NOTICE OF DECISION

SUBDIVISION / CLASS 2 ADJUSTMENT CASE NO.: SUB-ADJ18-04

SUMMARY: A Tentative Subdivision to divide property approximately 4.08 acres in size into four lots between 0.92 acres and 1.85 acres in size with an adjustment to allow two of the lots to be flag lots.

LOCATION: 2282 Claxter Road NE / 97301

TENTATIVE SUBDIVISION
PLAN

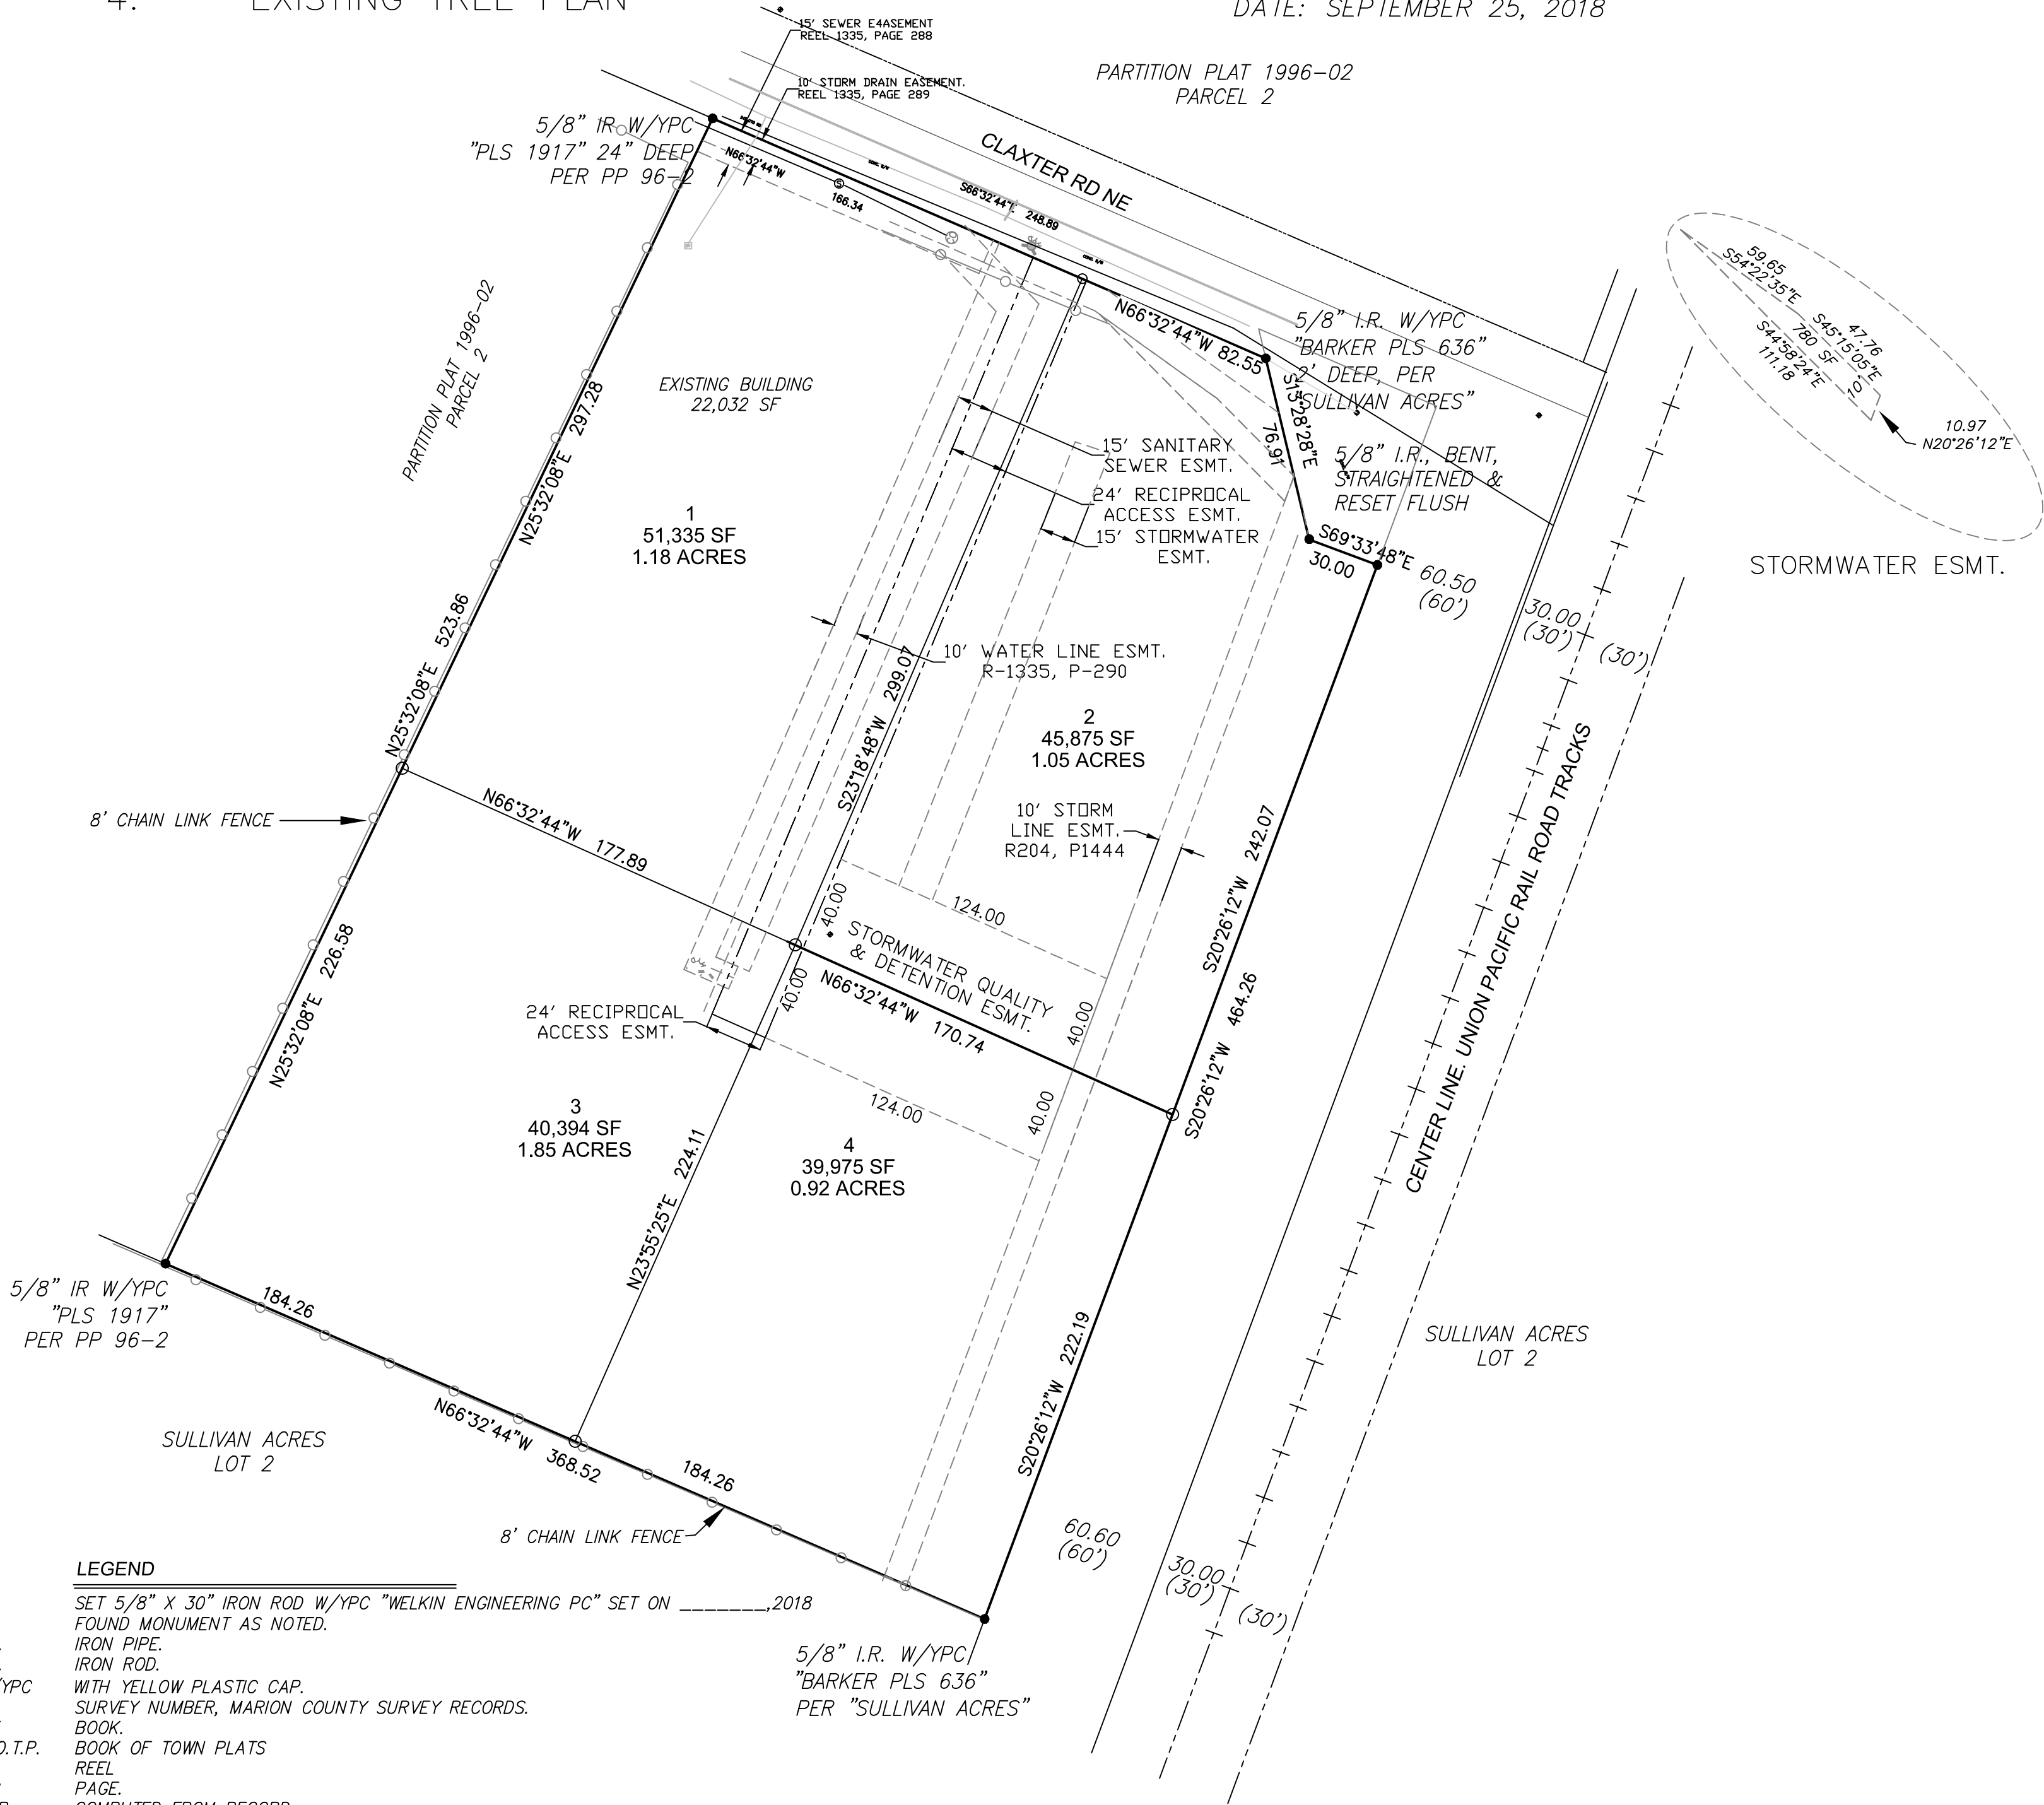
SRC 800.025 (Flag Lots): Subsection (c) establishes standards for flag lots and flag lot accessways. Pursuant to SRC Chapter 800, Table 800-1, flag lot accessways serving 1-4 lots on nonresidential zoned property must have a maximum length of 400 feet, minimum width of 25 feet, and minimum pavement width of 20 feet. The tentative plans submitted by the applicant show an approximately 300-foot-long, 24-foot-wide access easement that is currently paved within proposed Lots 1 and 2 and currently unpaved in proposed Lots 3 and 4. The conditions of approval for the adjustment require a 5-foot-wide paved pedestrian path on the east side of the vehicle accessway. To conform to the flag lot accessway standards and accommodate a paved pedestrian path, the following condition is required:

systems or where geographic features make it impractical and an alternative means of fire protection is provided and approved by the Fire Marshal. The tentative plan does not include a turnaround, no buildings are proposed for proposed Parcels 2, 3, and 4 at this time, and no geographic features make a turnaround impractical. The following conditions are required to ensure compliance:

The existing conditions plan indicates that the existing parking area on proposed Lot 1 has the 5-foot-wide paved pedestrian pathway abutting the building, striping for space lengths of approximately 18 feet, striping for space widths of 8 to 9 feet, and a drive aisle width of approximately 60 feet serving those spaces; adequate area exists to provide 19-foot-long spaces. The proposed tentative plan indicates that the access easement would be within the current 60-foot-wide drive aisle; the closest edge of the access easement would be approximately 17 feet from the end of a 19-foot-long standard space. The access easement, which would be widened to 30 feet in width as conditioned, straddles the property lines between proposed Lots 1 and 2 and proposed Lots 3 and 4.

Condition 1: Increase the width of the proposed access easement to 30 feet.

Condition 2: Modify the accessway to include a turnaround meeting Salem Fire Prevention Code standards.

TENTATIVE SUBDIVISION
UTILITY PLAN

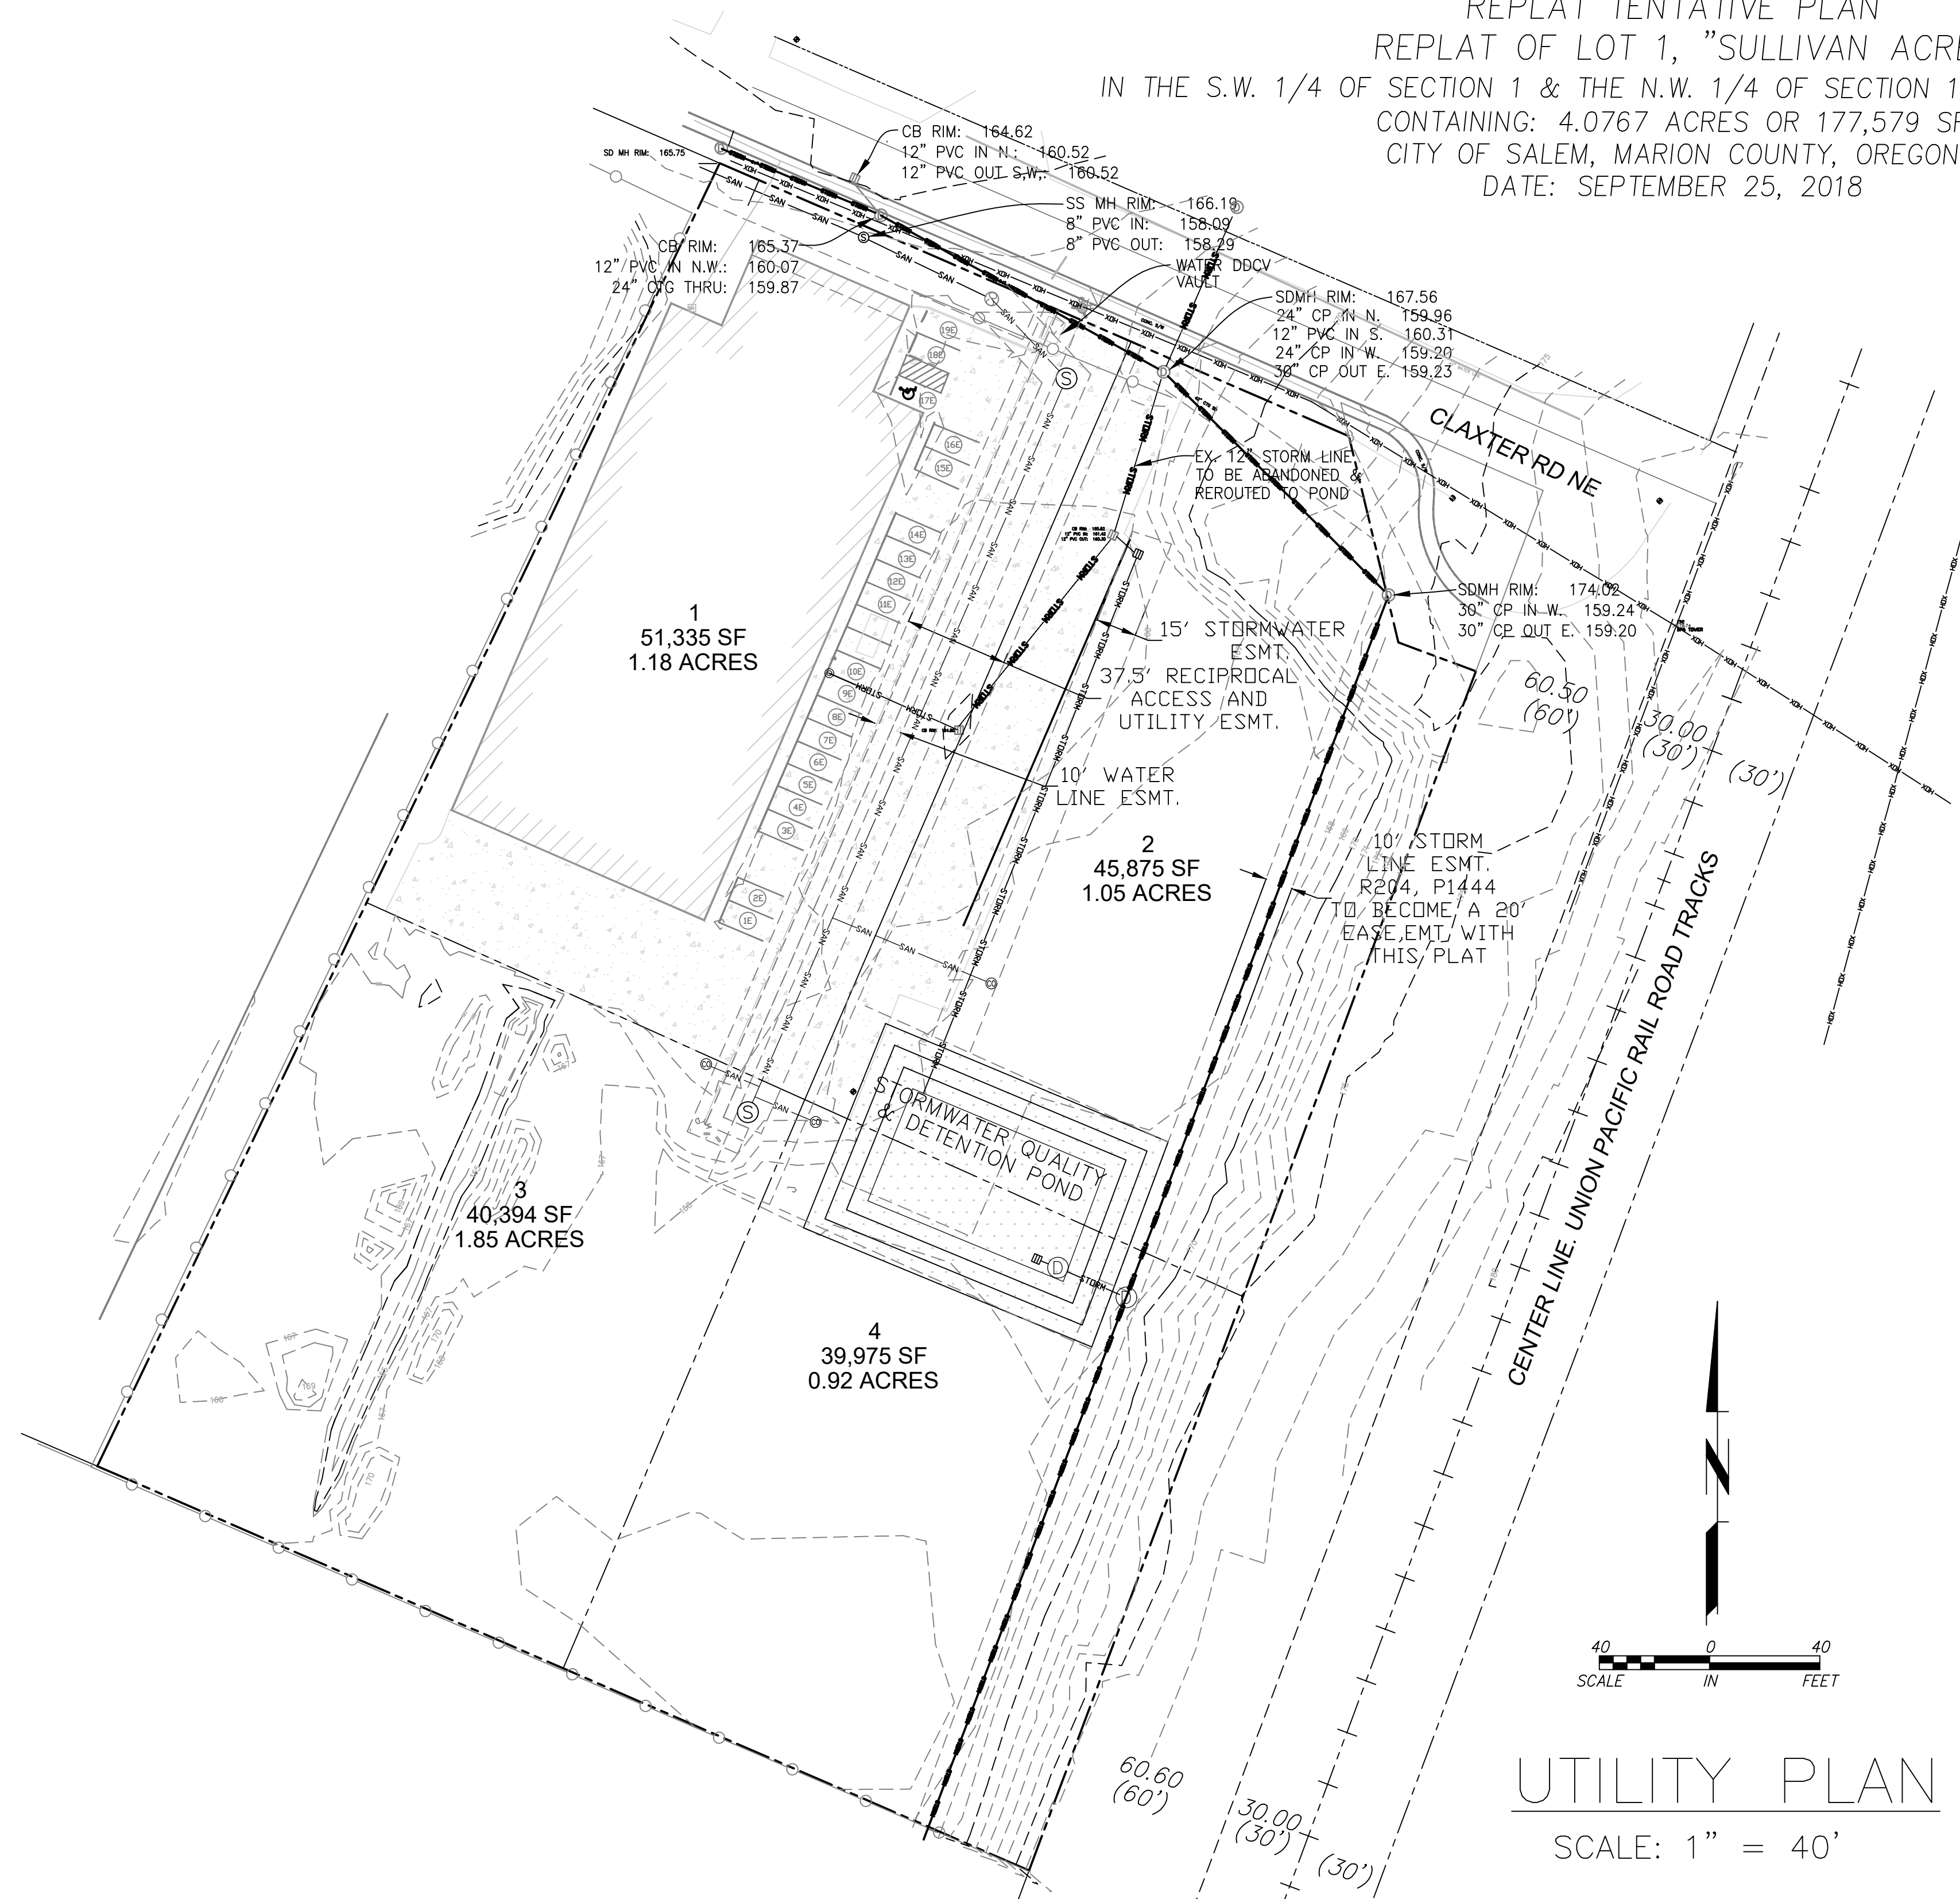
Finding: Water and sewer infrastructure is available along the perimeter of the site and appears to be adequate to serve the property, except as follows: The easterly terminus of the existing sewer main does not comply with PWDS. The applicant's tentative utility plan proposes a public sewer main to be located within the subject property; this proposal does not meet PWDS except under a Design Exception approved by the City Engineer. At a minimum, the applicant shall be required to extend the existing sewer main abutting the subject property as needed to serve all lots pursuant to PWDS.

The proposed development is subject to SRC Chapter 71 and the revised PWDS as adopted in Administrative Rule 109, Division 004. The applicant's engineer submitted a report stating that the future stormwater system will comply with PWDS and SRC Chapter 71. The applicant shall design and construct a storm drainage system at the time of development in compliance with SRC Chapter 71 and PWDS.

Condition 5: Design and construct water, sewer, and stormwater systems and provide access and utility easements to serve all proposed lots in compliance with PWDS and ORS 92.090.
